**STAFF REPORT**  
(One Step Final Plat)

**CASE NUMBER:** S/D 99-72 -- TIMBERWOLF ADDITION

**LOCATION:** East of 183<sup>rd</sup> St. West, North side of 117<sup>th</sup> St. North

# CLOSURE COMPUTATIONS "TIMBERWOLF ADDITION"

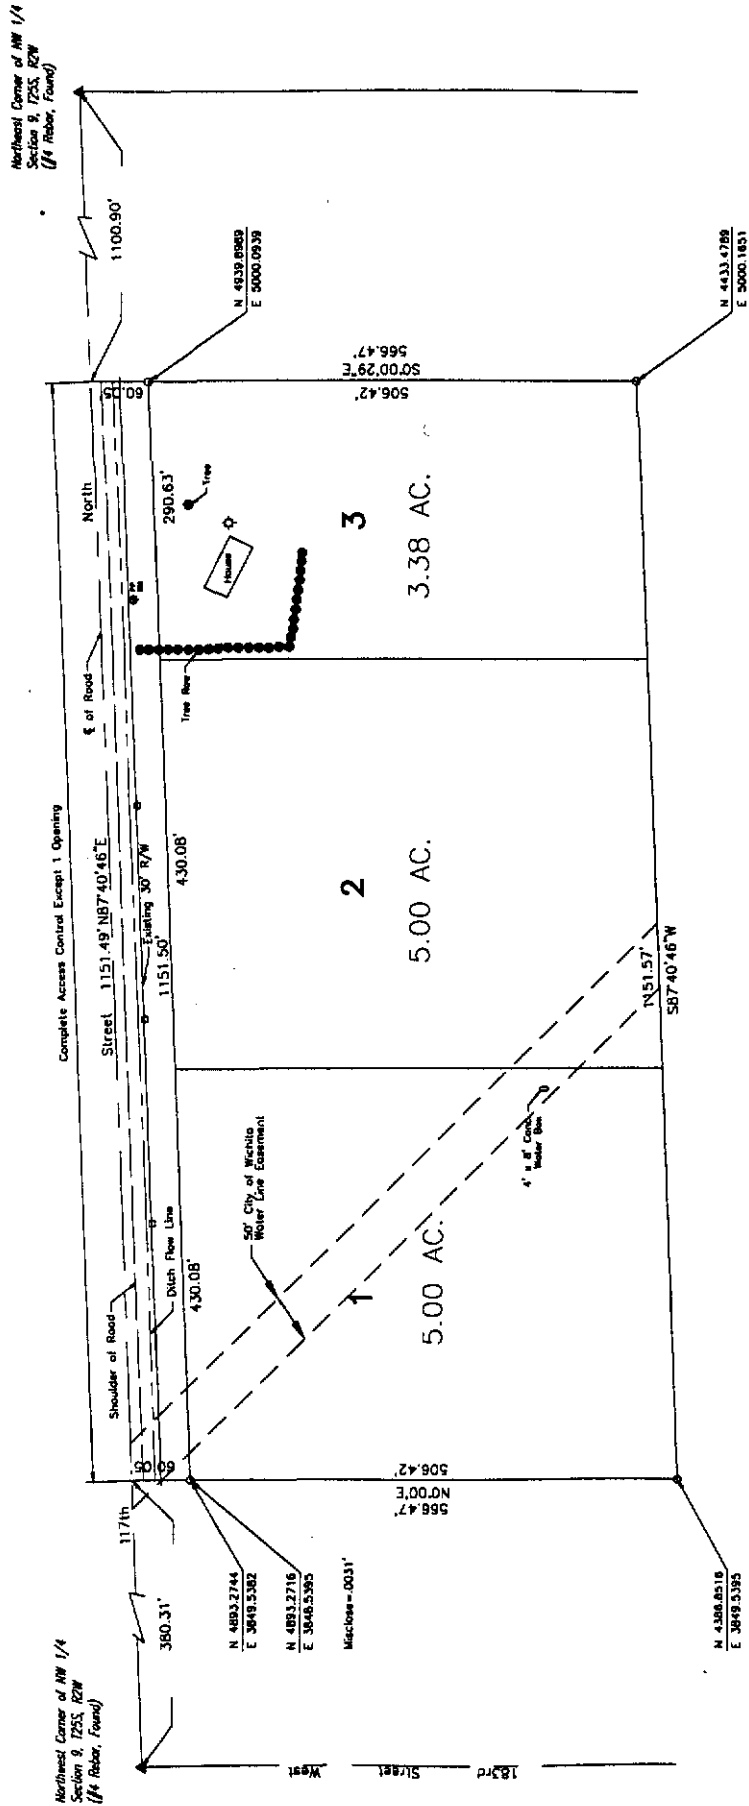
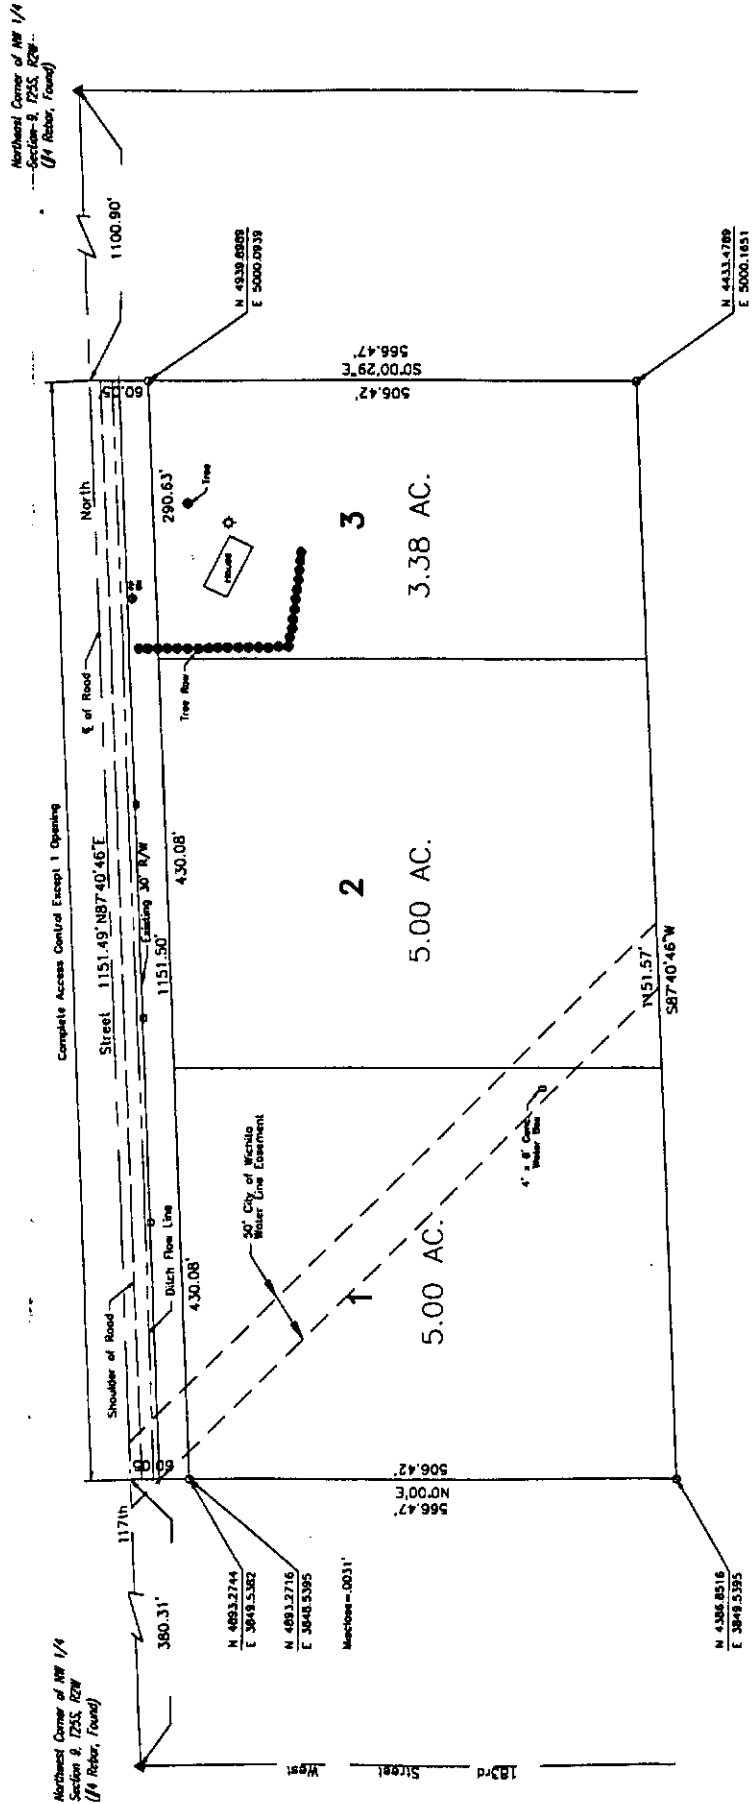
- C. County Engineering needs to comment on the status of the applicant's drainage plan.
- D. The Applicant proposes to dedicate access control except for one opening per lot along 117<sup>th</sup> St. North. The face of the plat shall be revised to reference "one opening per lot". The plat's text shall note that the access controls are being dedicated to the appropriate governing body.

- G. The plat's text shall include language that a drainage plan has been developed for the plat and that all drainage easements, rights-of-way, or reserves shall remain at established grades or as modified with the approval of the applicable City or County Engineer, and unobstructed to allow for the conveyance of stormwater.

- M. Perimeter closure computations shall be submitted with the final plat tracing.
- N. Recording of the plat within thirty (30) days after approval by the City Council and/or County Commission.
